Docket No. 50-322 Official Exh. No. D-74

In the matter of LILCO

## LIQUID PENETRANT EXAMINATION REPORT

COMPONENT NO. C3-315A

CYLINDER #1 LOWER PORTING

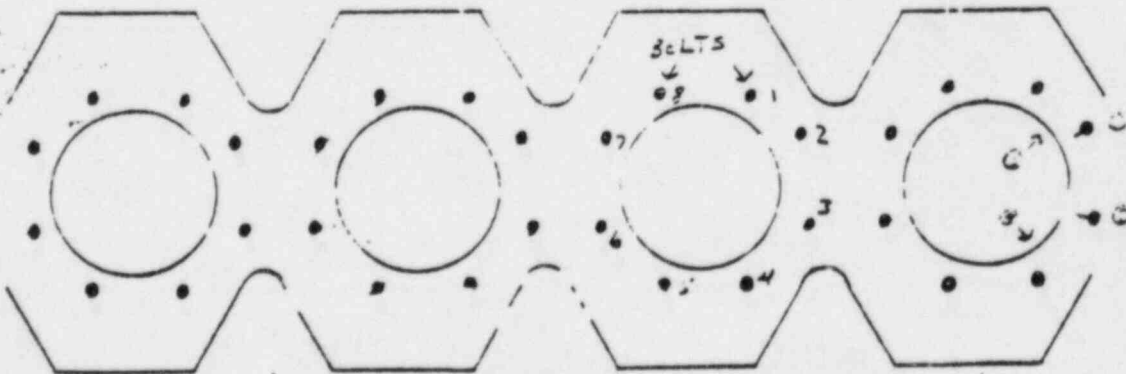
4. DEVELOPER		<i>MAGNAFLUX</i>	<i>SKC-NF/70-72</i>	<i>834041</i>		
5. POST EXAMINATION CLEANER		<i>MAGNAFLUX</i>	<i>SKC-NF/70-73</i>	<i>841025</i>		
C. EVALUATION						
SKETCH OR OTHER DETAIL: USE OTHER SIDE IF NECESSARY <i>CYLINDER #1 LOWER PORTING</i> <i>SEE SKETCH ON PAGE 1 OF 2</i>						
REPORT BELOW THOSE INDICATIONS OBSERVED AND THE PERTINENT INFORMATION REQUIRED. WHERE ADDITIONAL SPACE IS REQUIRED USE OTHER SIDE.						
LOCATION	SIZE (INCHES)	DESCRIPTION	ACTION (ACCEPT/REJECT, AND COMMENT AS NECESSARY)			
1 SEE SKETCH	.15"	LINEAR	REJECT, 19 1/2" LONG, 15" DIAMETER, SHARP EDGES, 2" DIA.			
2 SEE SKETCH	.25"	LINEAR	REJECT, 10 1/4" LONG, 25" DIAMETER, SHARP EDGES, 2" DIA.			
3 SEE SKETCH	6"	LINEAR	REJECT, 18 1/2" LONG, 6" DIAMETER, SHARP EDGES, 2" DIA.			
4 SEE SKETCH	8.75"	INTERMITTENT LINEAR	REJECT, 4' LONG, 8.75" DIAMETER, SHARP EDGES, 2" DIA.

ITEM	QTY	DESCRIPTION(S) AND INSPECTION REMARK(S)
2	1	<p>PERFORMED LP FLAMING ON CYL #1 UNDER BURNING. UNSAT.</p> <div data-bbox="457 880 1090 1034"><p>LANDING FACE</p><p>LANDING</p></div> <p>CYLINDER = 4</p> <p>= 3</p> <p>= 2</p> <p>= 1</p>  <div data-bbox="386 1668 1212 1864"><p>LANDING FACE</p><p>INTERMEDIATE INCH</p><p>4 1/2 INCH</p><p>12 INCH</p><p>LANDING</p></div> <p>M&amp;TE NO. _____</p>

*CYLINDER #2 LINEAR INDICATION*

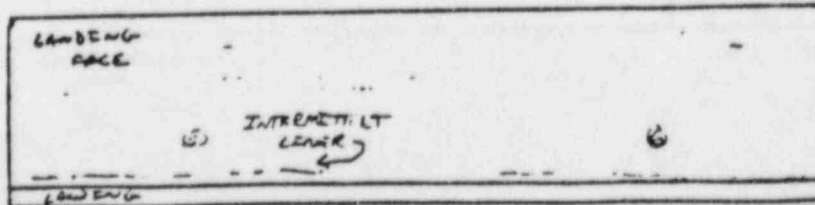
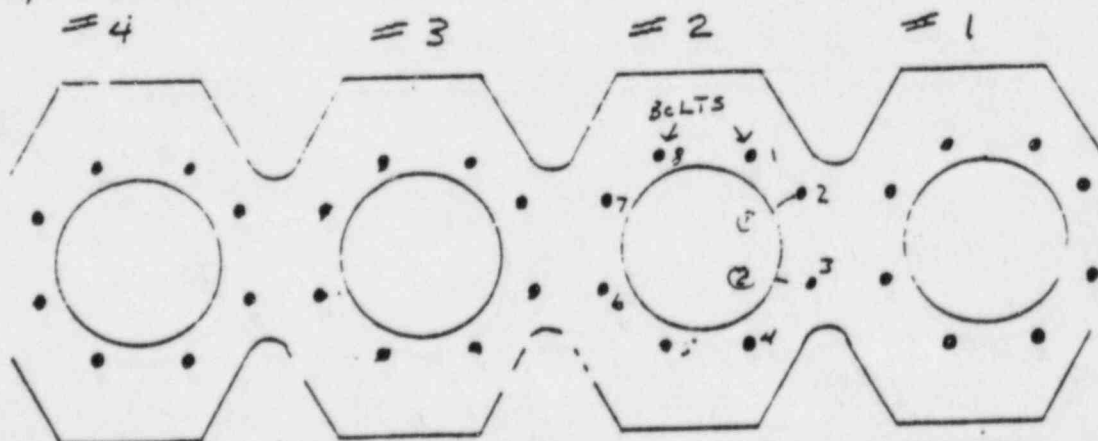
LOCATION	SIZE (INCHES)	DESCRIPTION	ACTION (ACCEPT/REJECT, AND COMMENT AS NECESSARY)
<i>2 SEE SKETCH</i>	<i>1.25"</i>	<i>LINEAR</i>	<i>.65" DOWN LANDING FACE REJECT, 11" LINEAR FROM 2" HOLE TO LANDING</i>
<i>2 SEE SKETCH</i>	<i>9/16" .65"</i>	<i>LINEAR</i>	<i>.5" DOWN LANDING FACE REJECT, .15" LINEAR ON ROST OF LANDING</i>
<i>3 SEE SKETCH</i>	<i>1/16"</i>	<i>LINEAR</i>	<i>REJECT 18" .65" LINEAR ON LANDING FACE</i>
<i>4 SEE SKETCH</i>	<i>1.1"</i>	<i>LINEAR</i>	<i>REJECT 16" LINEAR ON LANDING FACE</i>

2 1 PERFORMED LP FIRM ON CYL #2 LINE LANDING UNSAT.

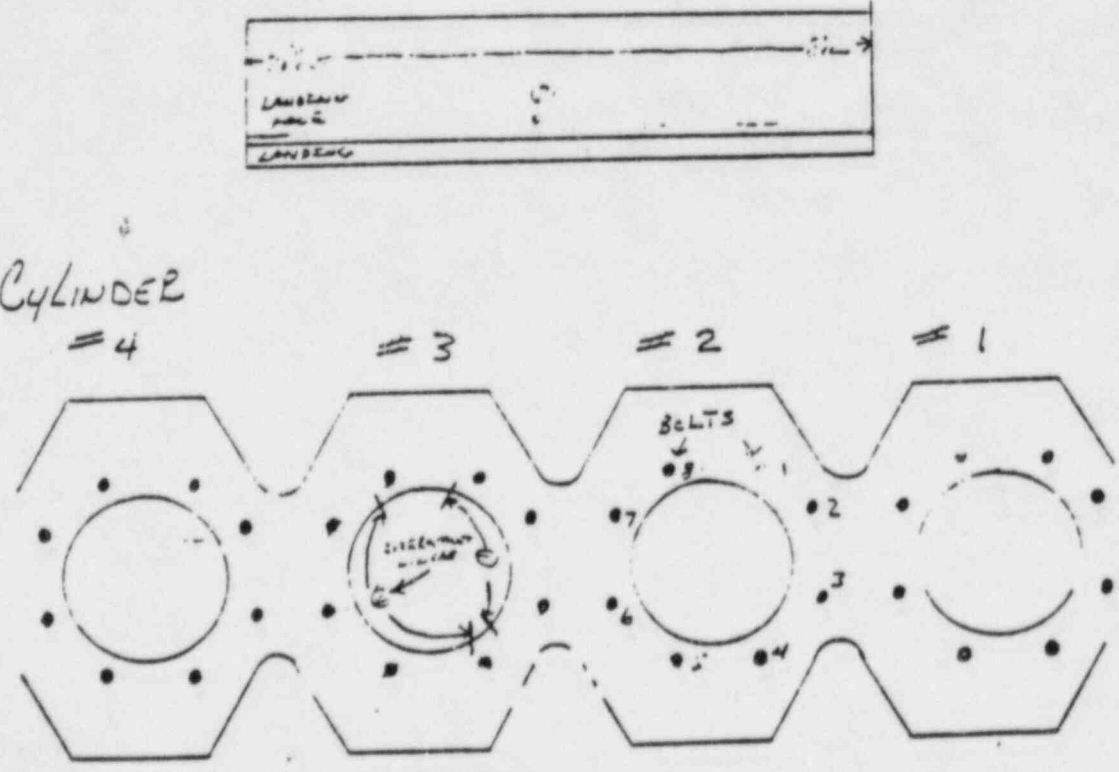
LOCATION	SIZE (INCHES)	DESCRIPTION	ACTION (ACCEPT/REJECT, AND COMMENT AS NECESSARY)
1 SEE SKETCH	19"	LEAKAGE	REJECT 20% LEAKAGE 10% LEAKAGE 10% LEAKAGE
2 SEE SKETCH	36"	INDICATED LEAKAGE	REJECT 20% LEAKAGE 10% LEAKAGE 10% LEAKAGE
3			
4			
ACCEPTANCE CRITERIA	4.2	OPERATOR <u>John H. H. H.</u>	Level <u>1</u> Date <u>2/2/72</u>

ITEM	DESCRIPTION AND INSPECTION REMARKS
2	<p>PERFORMED EXTENSIVE CYLINDER LEAK TESTING. UNSAT.</p>  <p>LANDING PAGE</p> <p>M&amp;TE NO. _____</p>

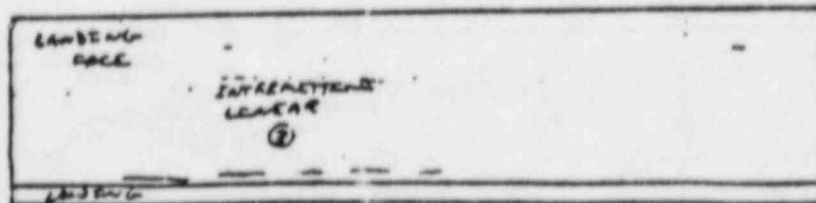
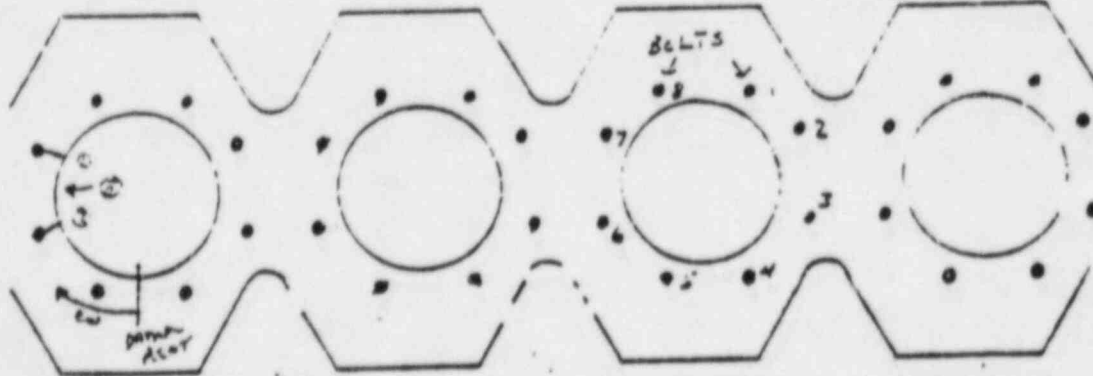
C. EVALUATION		REPORT BELOW THOSE INDICATIONS OBSERVED AND THE PERTINENT INFORMATION REQUIRED. WHERE ADDITIONAL SPACE IS REQUIRED USE OTHER SIDE.			
LOCATION	SIZE (INCHES)	DESCRIPTION	ACTION (ACCEPT/REJECT, AT JUDGMENT AS NECESSARY)		PLANT/LOCATION 20-101
1 SEE SKETCH	2.1"	LEAKAGE	1.5" LEAKAGE LOW PRESSURE 100X REJECT, 100X		
2 SEE SKETCH	1.7"	LEAKAGE	1.5" LEAKAGE LOW PRESSURE 100X REJECT, 100X		
3 SEE SKETCH	1.1"	LEAKAGE	1.5" LEAKAGE LOW PRESSURE 100X REJECT, 100X		
4

2 1 REFERRED TO DRAWING IN CYLINDER FOR LENS AND LENS HOLDER

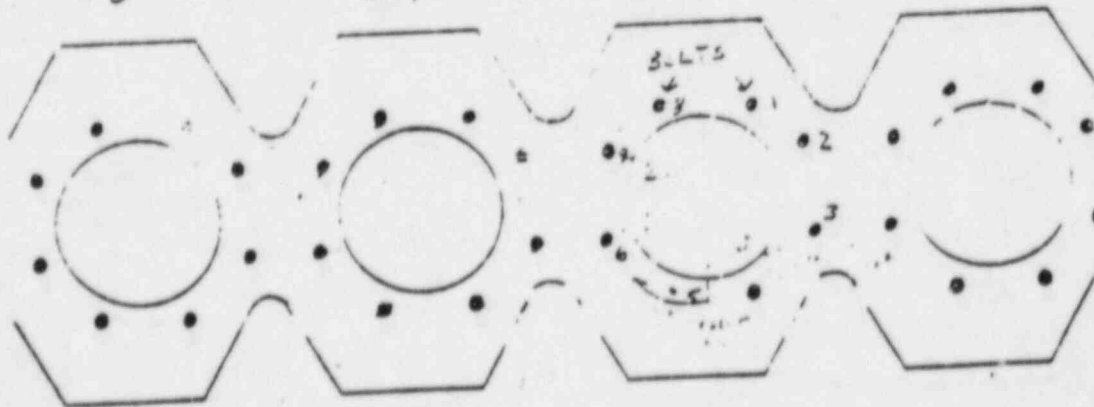
C. EVALUATION		REPORT BELOW THOSE INDICATIONS OBSERVED AND THE PERTINENT INFORMATION REQUIRED. WHERE ADDITIONAL SPACE IS REQUIRED USE OTHER SIDE.			
LOCATION	SIZE (INCHES)	DESCRIPTION	ACTION (ACCEPT, REJECT AND COMMENT AS NECESSARY)		
1 SEE SKETCH	1.2"	LEAKAGE	REJECT, 12" dia. hole in flange		
2 SEE SKETCH	1.6"	LEAKAGE	REJECT, 1.6" dia. hole in flange		
3 SEE SKETCH	.25"	LEAKAGE	REJECT, 12" dia. hole in flange		
4
